80C186XL/80C188XL EMBEDDED MICROPROCESSORS SPECIFICATION UPDATE

Release Date: June, 1997
Order Number: 272895.002

Figure 2. Incorrect INT1 Acknowledge Sequence with Higher Priority Timer Interrupt

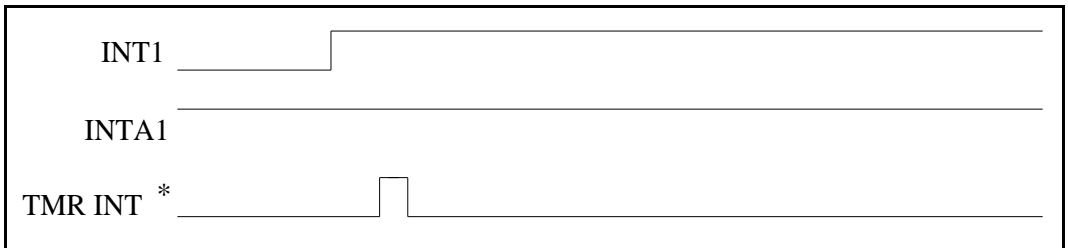
The errata occurs when a higher priority interrupt occurs between INT1 and its expected acknowledge. The processor completes internal interrupt acknowledge cycles as seen on the status lines but no acknowledge cycle is sent on the INTA1# output (Figure 2).

Figure 3. INT0 And INT1 Acknowledge Failure Due to Higher Priority Timer Interrupt

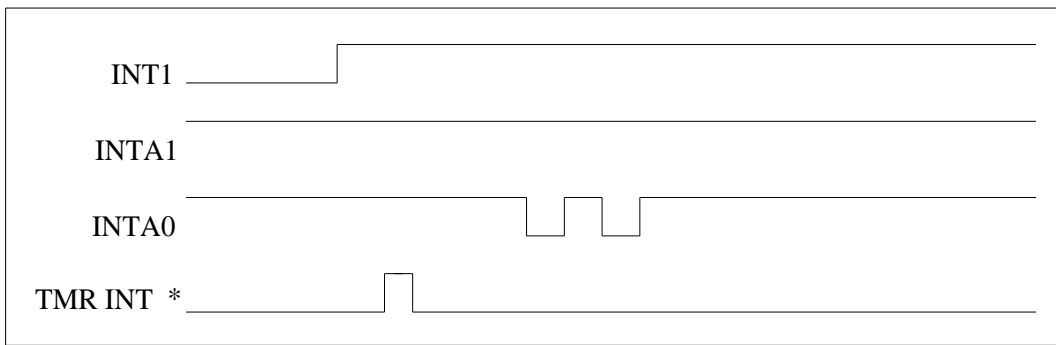
If INT0 and INT1 are configured in cascade mode and a higher priority interrupt occurs between INT1 and its expected acknowledge, then the acknowledge will appear on INTA0# instead (Figure 3).

Figure 5. Incorrect INT0 Acknowledge Operation with a Simultaneous INT1

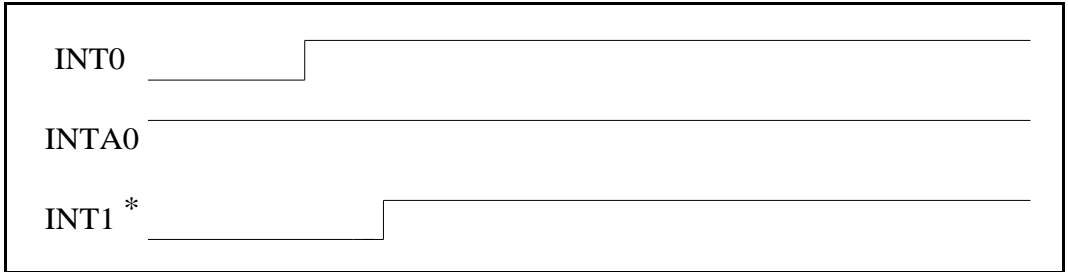
The errata occurs when INT1, which is higher priority than INT0, occurs between INT0 and its expected acknowledge. The processor completes internal interrupt acknowledge cycles as seen on the status lines but no acknowledge cycle is sent on the INTA0# output (Figure 5).

Figure 6. INT0 and INT1 Acknowledge Failure Due to the Higher Priority INT1

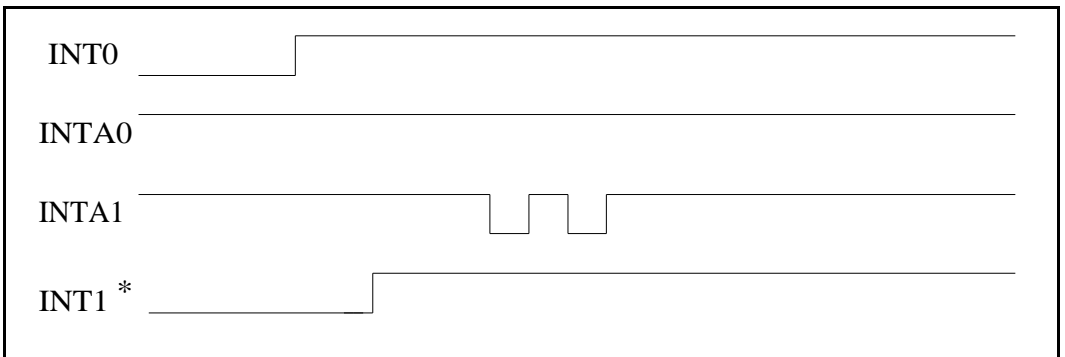
If INT0 and INT1 are configured in cascade mode and the higher priority INT1 occurs between INT0 and its expected acknowledge, then the acknowledge will appear on INTA1# instead of INTA0# (Figure 6).
